Fairhope Planning Commission Agenda

January 5, 2026 – 5:00 PM

SR 25.08 - Fairhope Boarding House

Request of the Applicant, S.E. Civil, LLC, on behalf of the Owner, FST SILDI, LLC, for Site Plan Approval of Fairhope Boarding House. The property is approximately 0.20 acres and is zoned B-2 – General Business District. The property is located at 301 Fairhope Avenue.

Rooftop Zoning Information:	
Total Roof Area =	7,933 sf
Allowable Covered Area (25%) =	1,983 sf
Allowable Stair and Elevator (7.5%) =	606 sf
Actual Covered Area =	1,965 sf
Actual Stair and Elevator Area =	428 sf

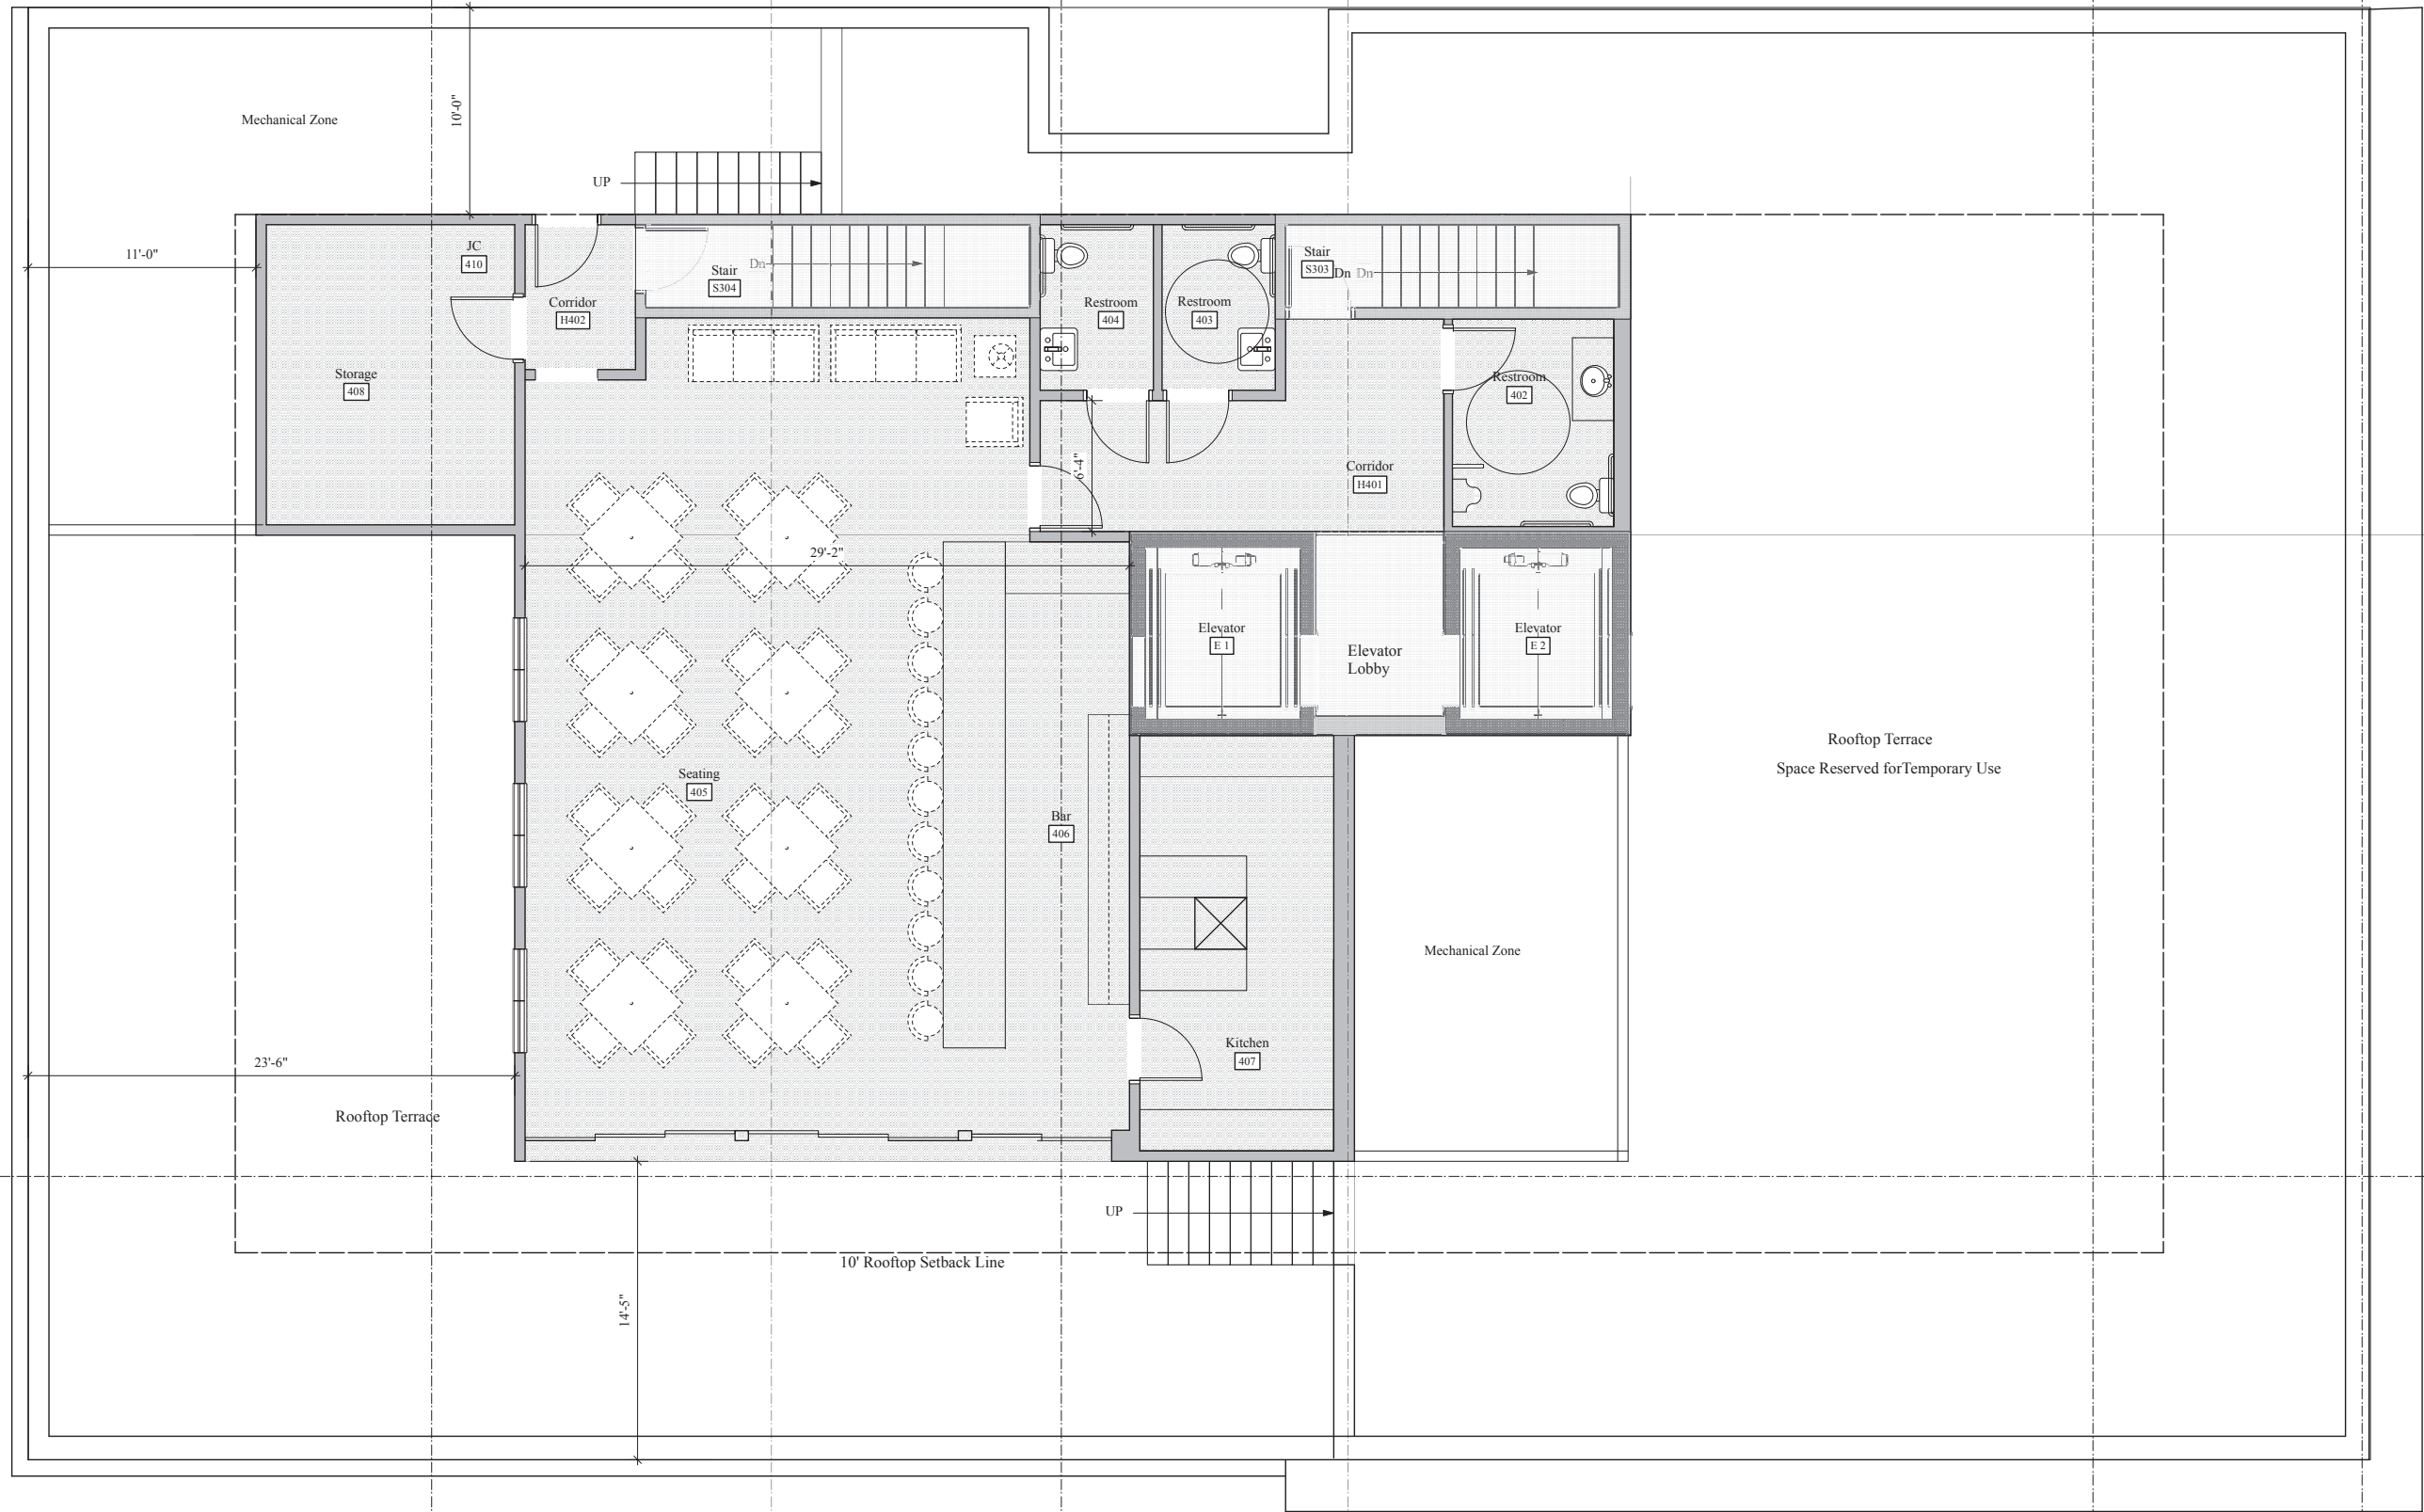
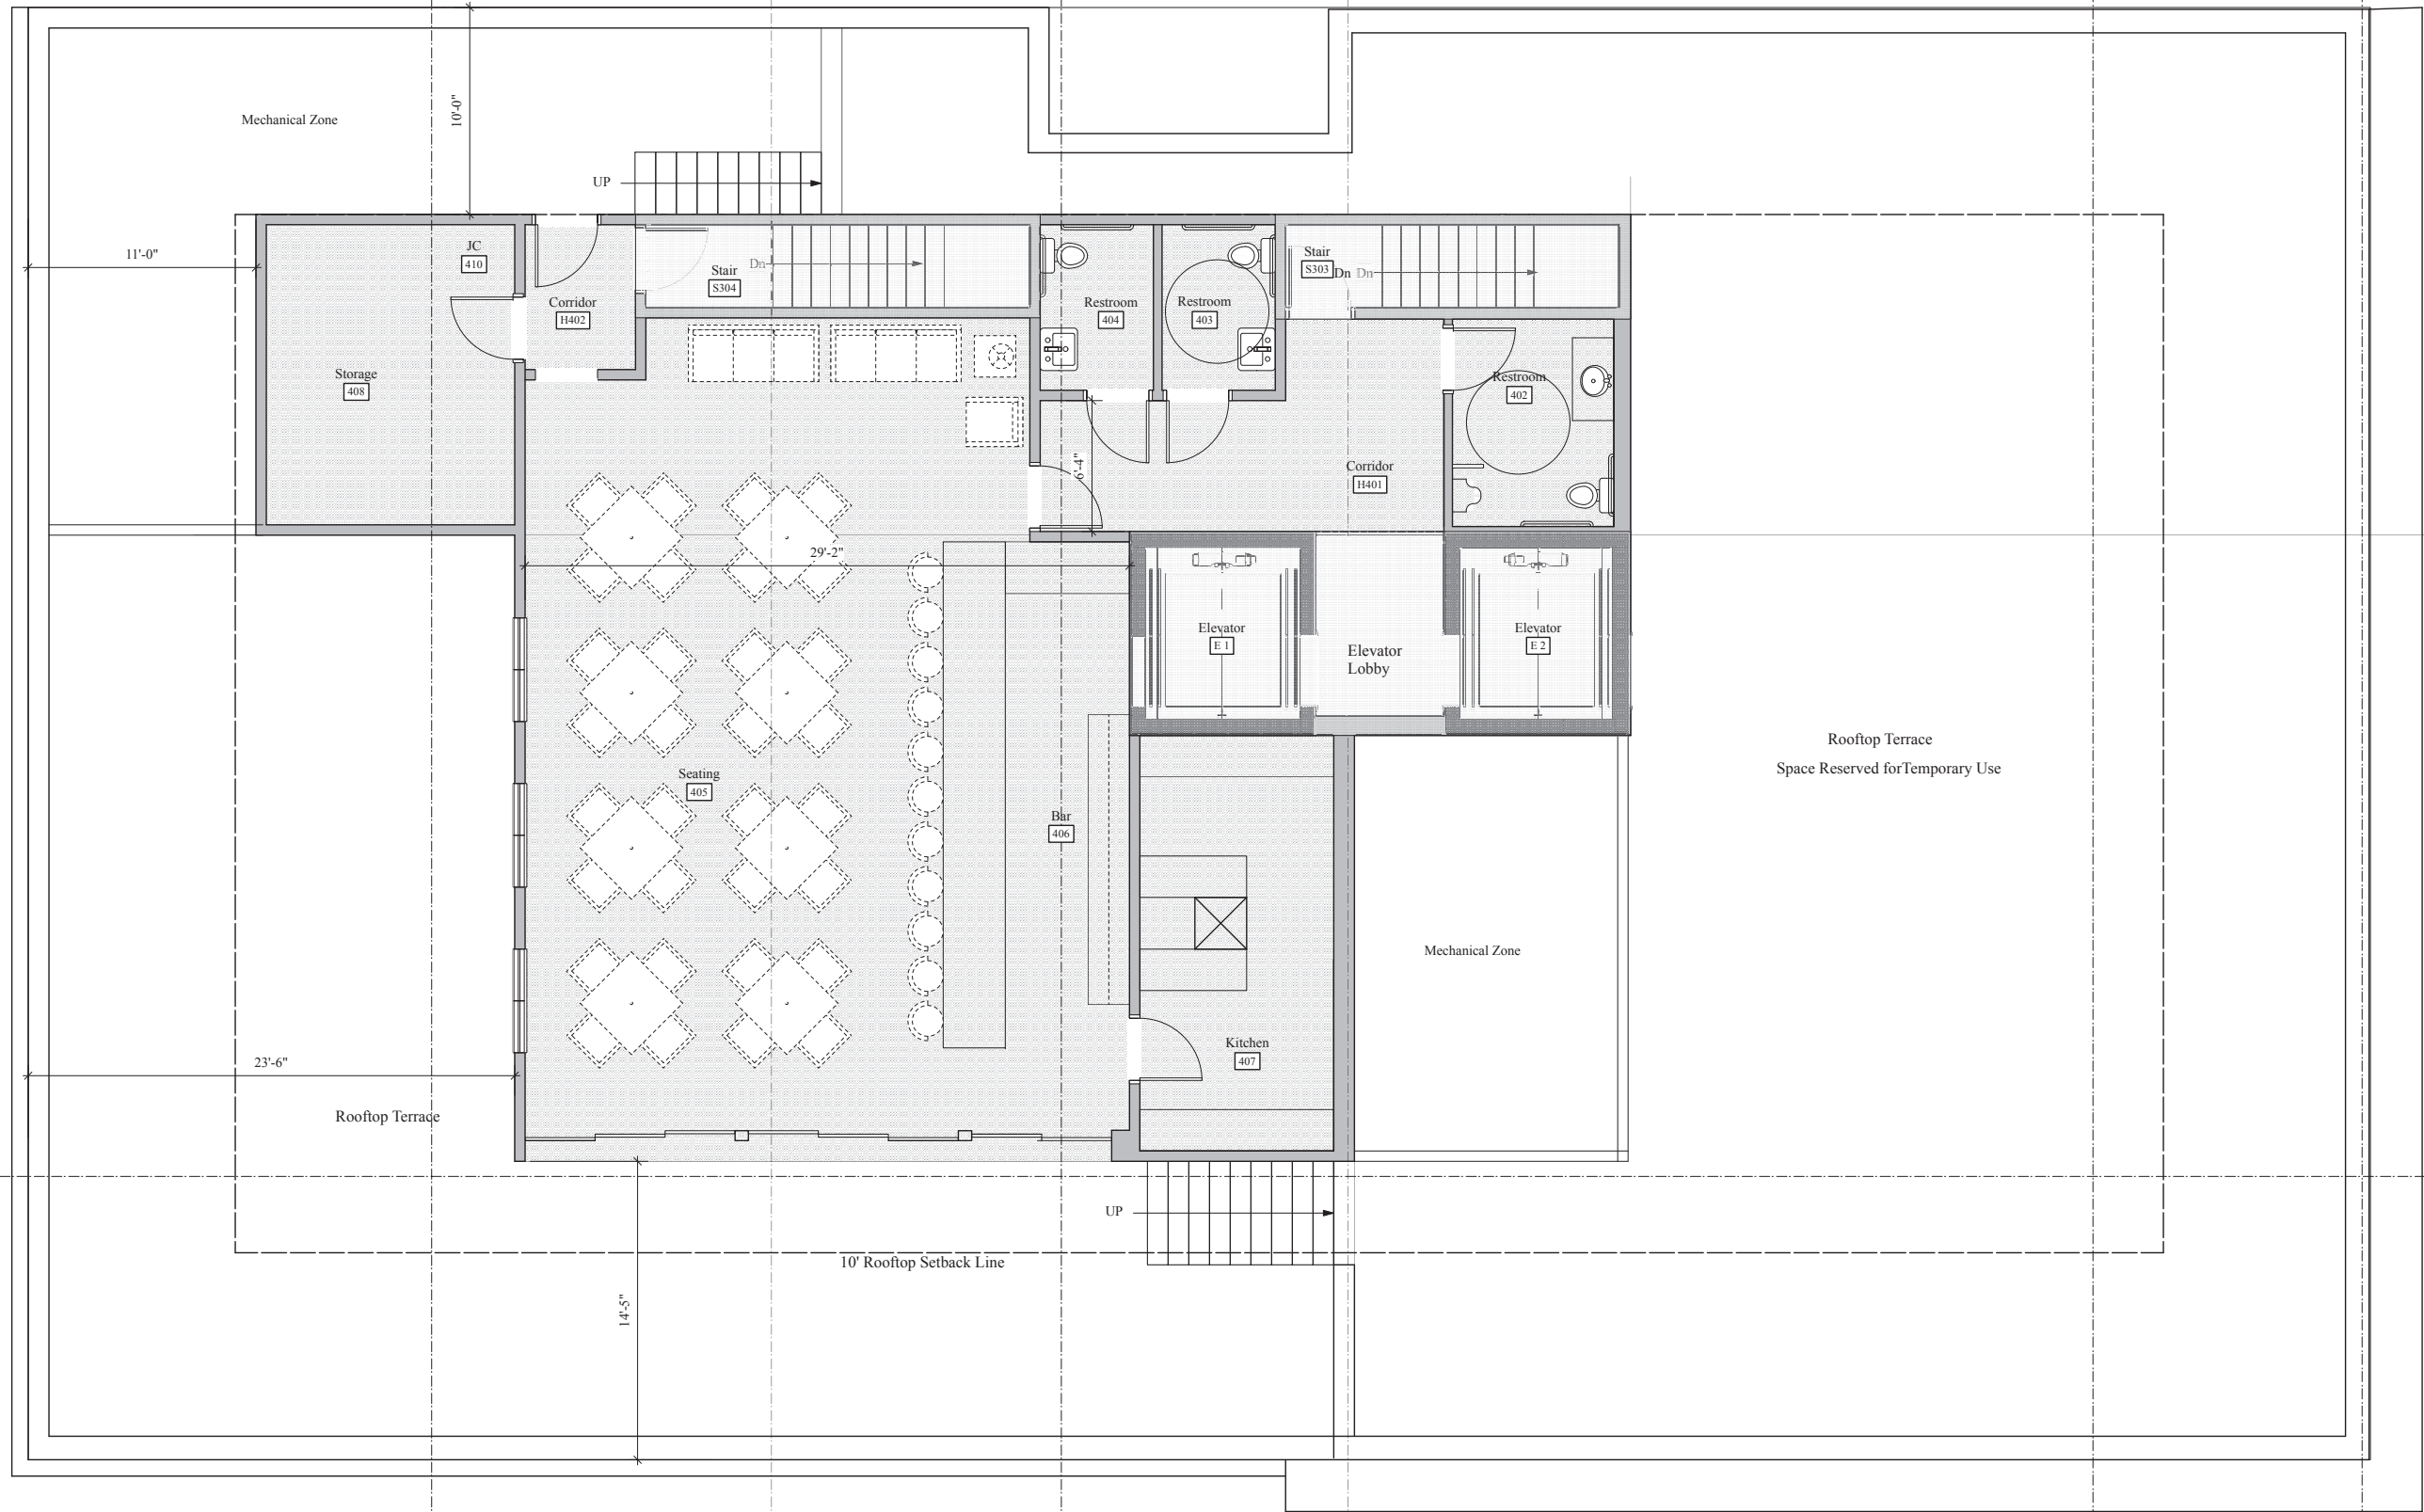
Article V, Section B(4)(c) of the Zoning Ordinance states that within the CBD "Building heights for all structures shall not exceed 40 feet or 3 stories". The proposed building height for the three-story structure does not exceed the aforementioned limitations. A rooftop terrace per the Zoning Ordinance has additional allowances that are currently being met for height. See *Article V, Section B(3)(a)*. Any substantial changes or alteration from the proposed Site Plan will require additional approvals from the Planning Commission and City Council.

All mechanical equipment is not shown. Applicant is aware that 40' is the height limit for all structures including mechanical equipment. The Architect shall verify at time of permitting the height of all mechanical equipment.
